CITY OF ENGLEWOOD MAJOR DRAINAGEWAY PLAN BASELINE HYDROLOGY - FINAL REPORT

SEPTEMBER 2022

Draft 1 Baseline Hydrology Report - Comment Responses

Figure 2-1 Project Area

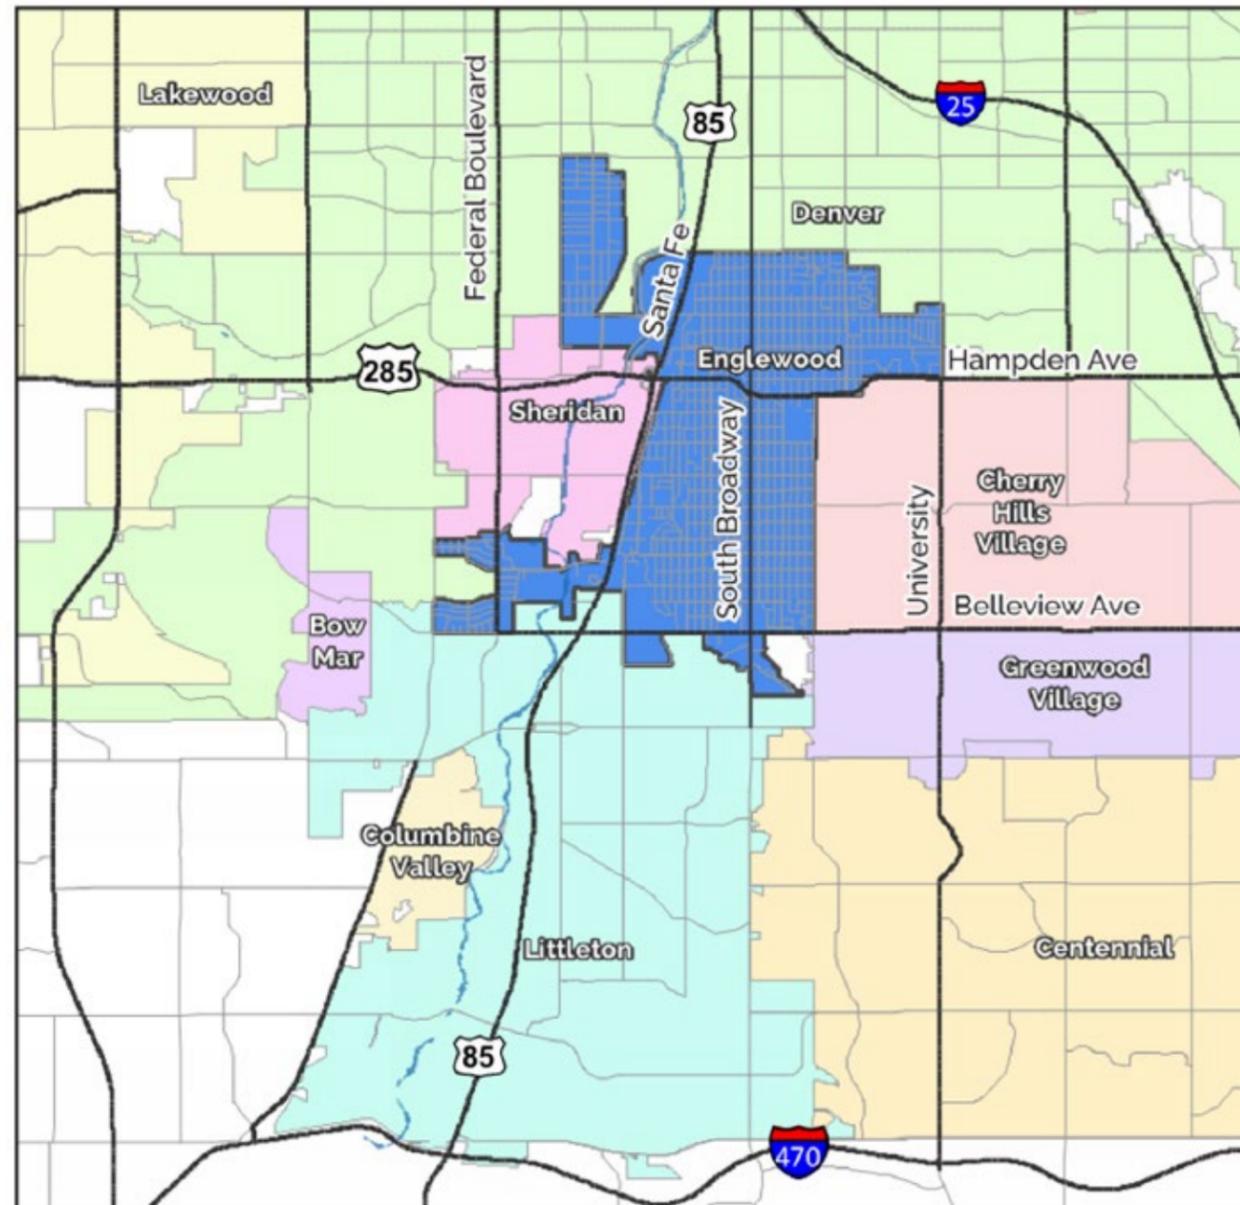
48	9	Figure 2-1	cpajares	Please differentiate between streams and ditches.	Ditches/Canals differentiated on figures.
49	9	Figure 2-1	cpajares	Should we scale this in miles?	Changed scale to miles.
50	10	3.3	THoos	Does this need to be addressed?	Please disregard. Areas have been picked up.
51	10	3.3	THoos	Do we know if any private ponds exist?	Per discussion with MHFD, no private ponds can be accounted for in the Baseline Hydrology however, areas of existing inadvertant ponding or detention will be considered for proposed detention facilities.
52	10	3.3	THoos	planimetric	Fixed.
53	10	Table 3-1	cpajares	1.95 per Table 3-3. Please update for consistency.	Updated for consistency.
54	10	3.3	cpajares	Is this correct? From contours or from DEM? Please specify.	Changed references to LiDAR and added description to Section 1.4 that the 1-foot contours and the DEM are from the 2013 DRCOG LiDAR.
55	10	3.3	cpajares	Are these correct? it seems like basins 116 and 119 are within the BowMar and Federal Basins?	Please disregard.

FIGURE B-1 SOILS MAP

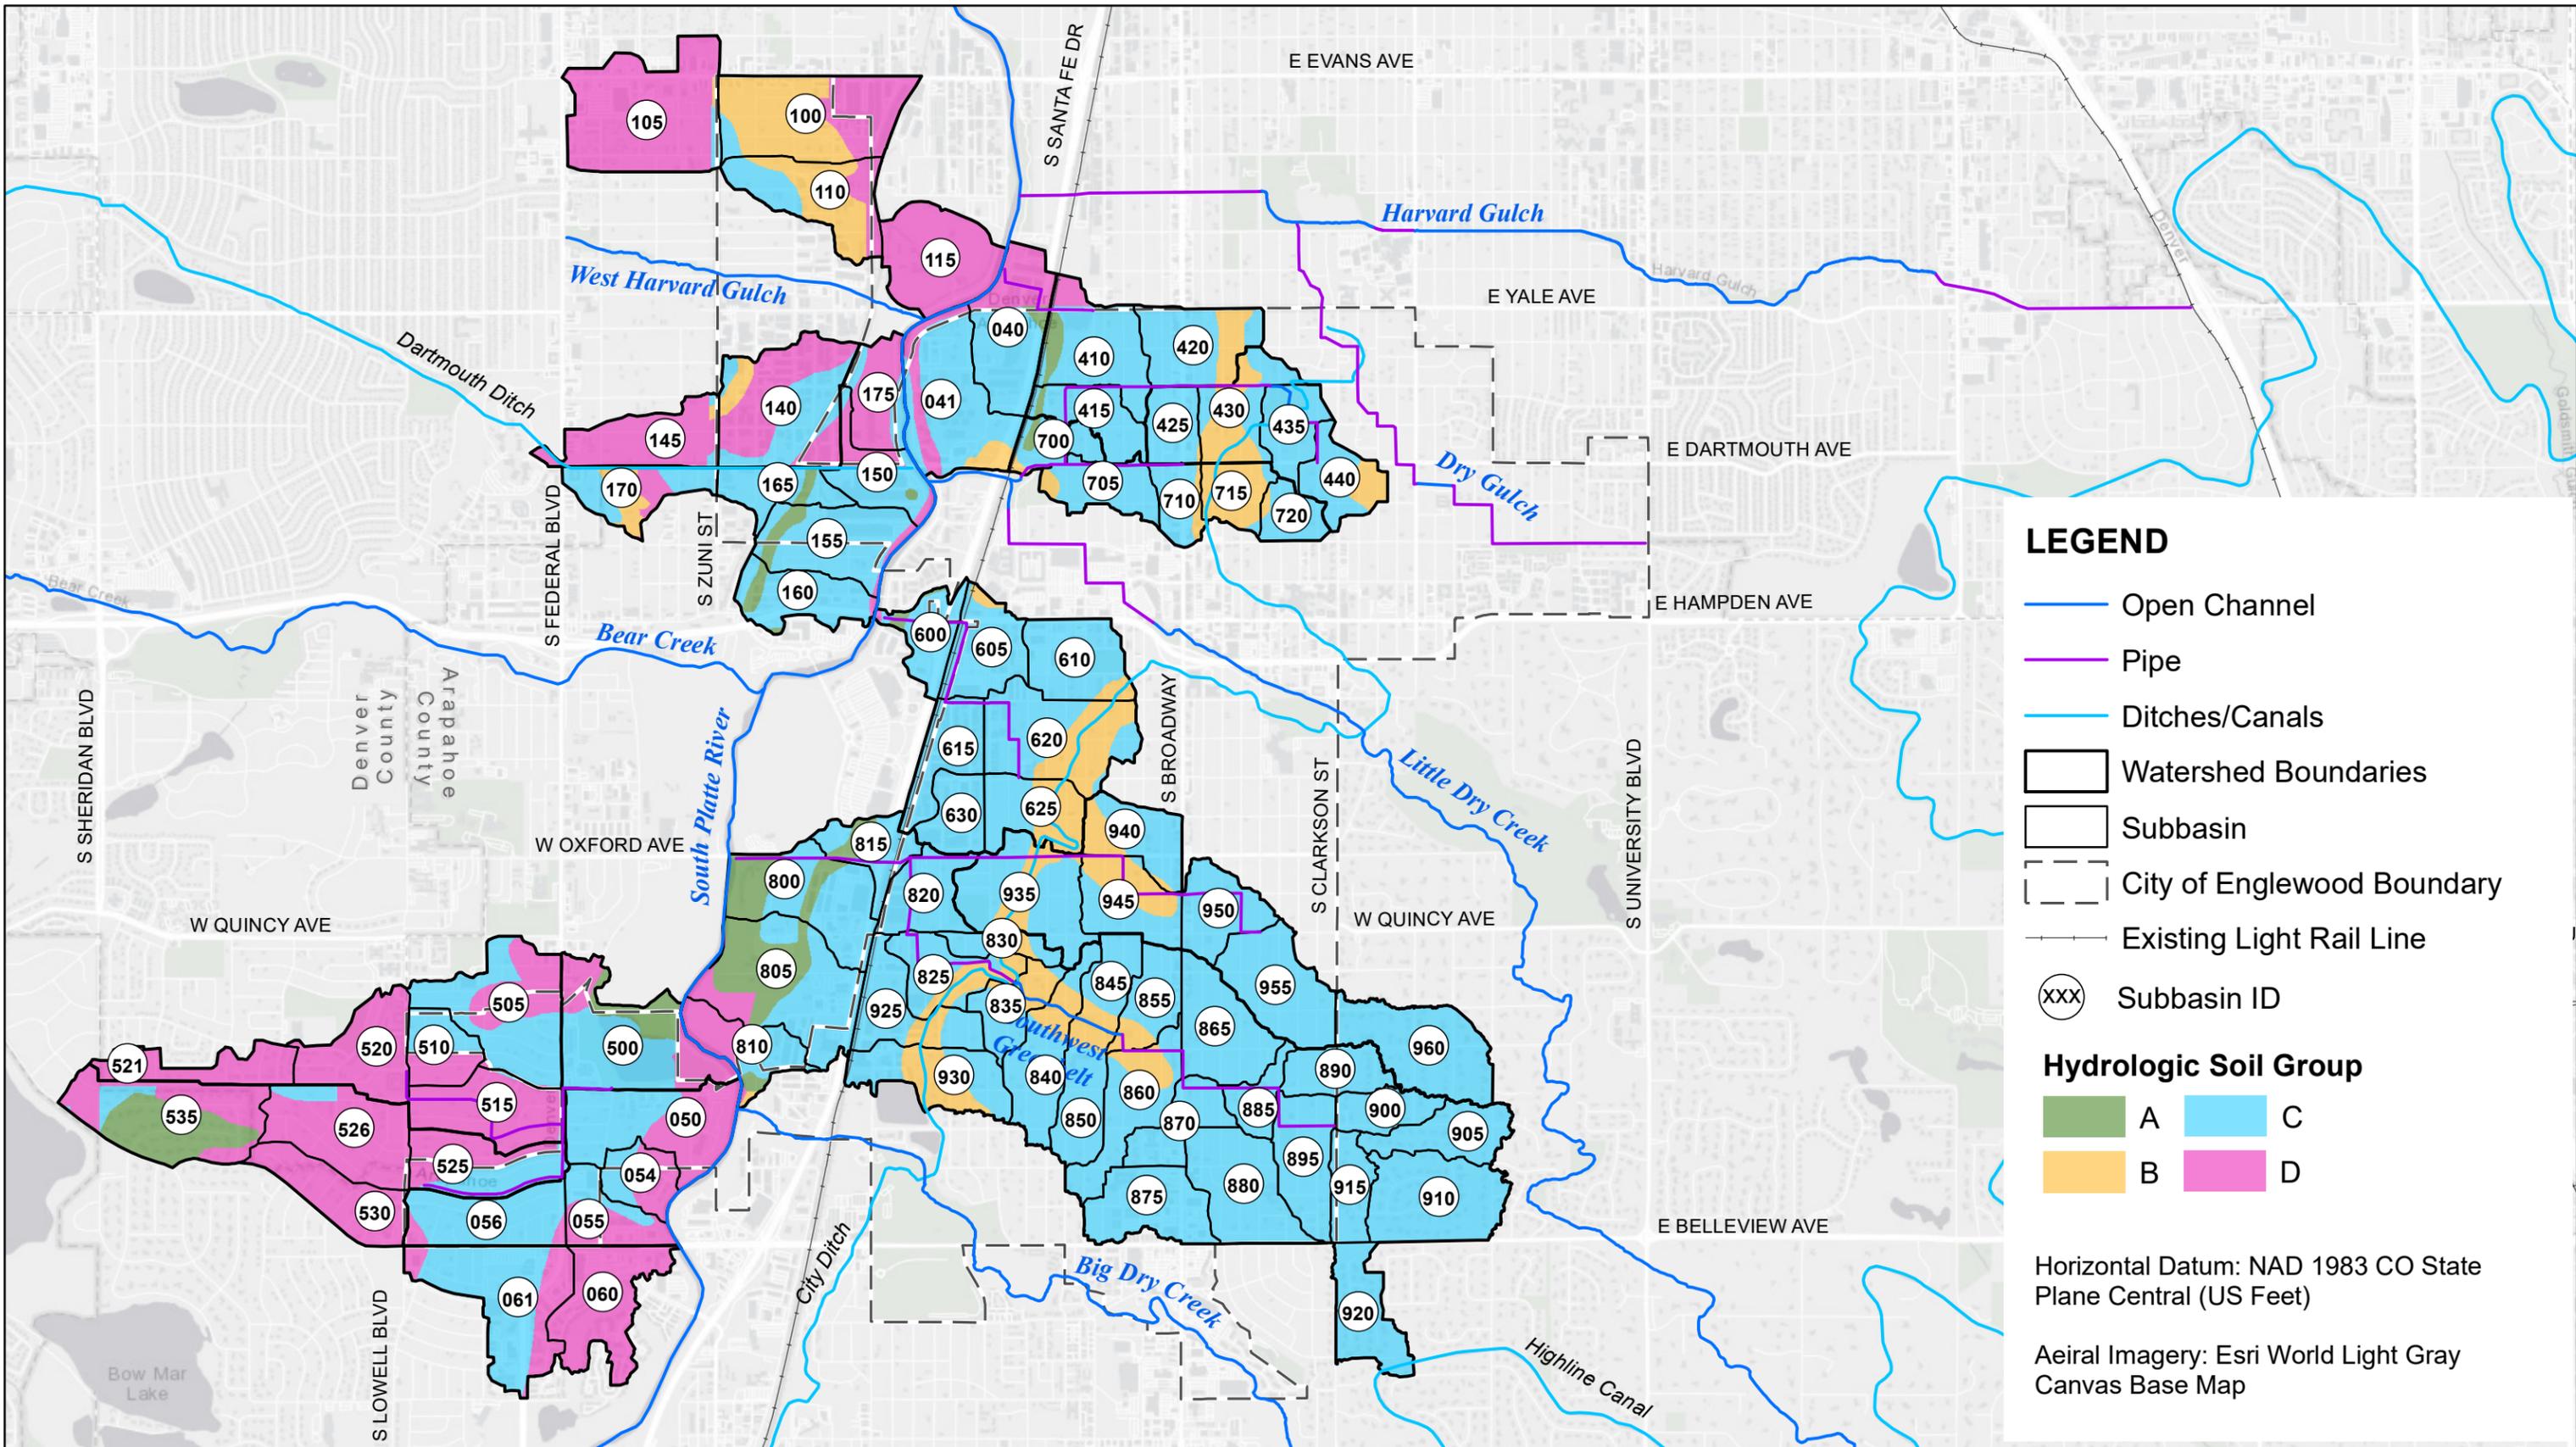
No.	Page	Section	Reviewer	Comment	Response
74	24	Figure B-1	cpajares	Is this showing that all that purple area is "undefined" in the planimetrics? Is there no category for grass or lawns? That's what most of it appears to be, right? This was all assigned 10% imp?	Yes, there was not a category for the "undefined" area in the planimetrics. Discussed during meeting & decided to supplement planimetrics with NLCD to replace "undefined" area. This increased the imperviousness into the 70's, but that appears to be more consistent with the "built-out" nature of the city. Updated impervious values were also compared against the Harvard Gulch and Dry Gulch MDP. Both our study and theirs puts the Dry Gulch area in the 50%.
75	25	Figure B-1	cpajares	is there a difference between page 24 and 25? please remove duplicate.	Duplicate removed.
76	27	Figure B-1	cpajares	Pond?	Made ponds more visible in SWMM schematic.

77	27	Figure B-1	cpajares	missing a few. ok if size is restrictive.	Noted.
78	-	CUHP	cpajares	Nodes 301 and 302 are included in the CUHP run, however they are not included in the SWMM model routing. Do these basins drain directly to SPR and thus are not accounted for? Or should they be routed to a divider between 661 and 660?	The following subbasins are not routed in SWMM because they flow directly to SPR or out of Englewood: 40, 41, 50, 54, 55, 100, 105, 110, 115, 175, 500, 805, 810. Subbasins 301 and 302 (now 40/41 and 405) flow directly to the SPR and north out of Englewood.
79	-	CUHP	cpajares	Please consider revising subcatchments 42, 43, <u>82</u> , 94, 96 and 302 which show questionable length to width ratios.	Subbasins were reviewed and revised to improve l/w ratios. All ratios are now =<7 except for subbasin 521. This subbasin was divided to improve the ratio to 8, but the nature of the area is long and narrow.
